Project:	Park Danforth
Location:	Portland, ME
Becker Job No:	3422

OBSERVATION REPORT

Cast in Place Concrete

Exterior depressed slabs on H line from 8-8.5 and 9-10.

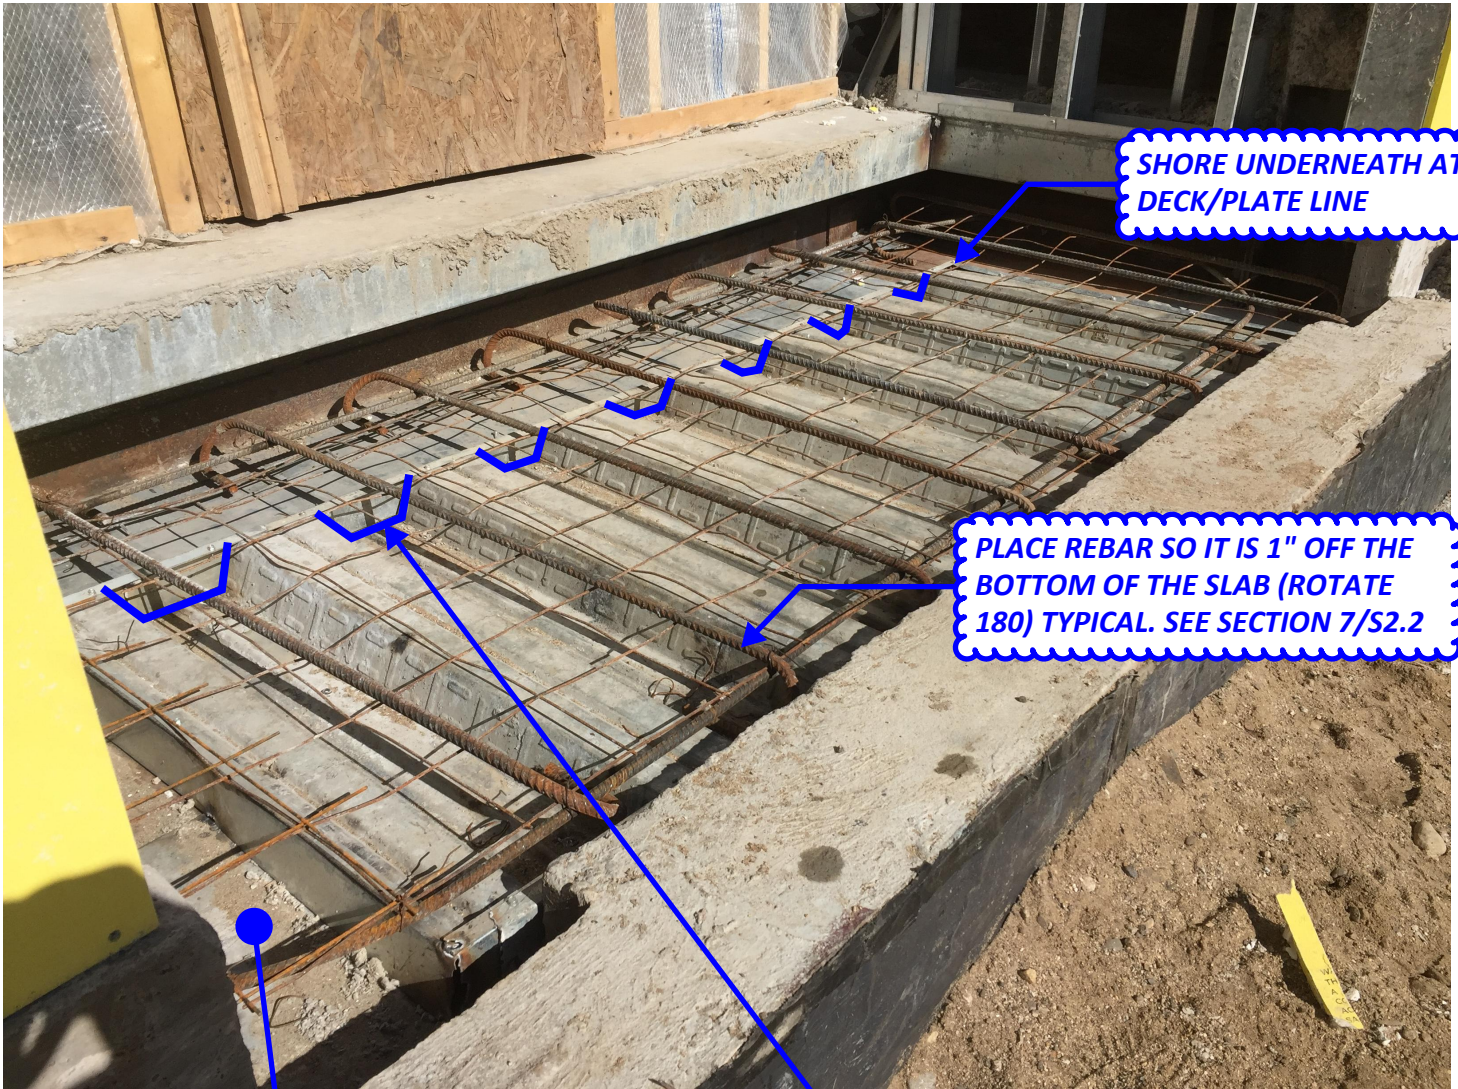
Deck construction of the depressed exterior slabs on H line from 8-8.5 and 9-10 were constructed improperly. Section 9/S3.3 was applied to the strong direction of the deck on G.8 line resulting in the deck being cut back from the support beams on G.8 line and a deck filler plate installed from the edge of the deck to the beam. At this location the GC has shored the deck for concrete placement. Additionally the rebar was installed at the top of the slab instead of at the bottom do to a conflict with the deck closure plate. The deck closure plate should be cut out at each deck flute to allow the rebar to be installed 1" from the bottom of the slab. The shoring shall remain in place until the slab has cured. I notified Andrew from PC of my findings. Please see attached markup for clarification.

SHORE UNDERNEATH AT DECK/PLATE LINE

PLACE REBAR SO IT IS 1" OFF THE BOTTOM OF THE SLAB (ROTATE 180) TYPICAL. SEE SECTION 7/S2.2

(2)#5 WITH 180 HOOKS IN BOTTOM OF SLAB WHERE DECK PLATE IS PARALLEL WITH DECK PER SECTION 9/S3.3

CUT OUT DECK CLOSURE STRIP AT EACH DECK FLUTE SO REBAR CAN BE 1" FROM BOTTOM OF SLAB TYPICAL.
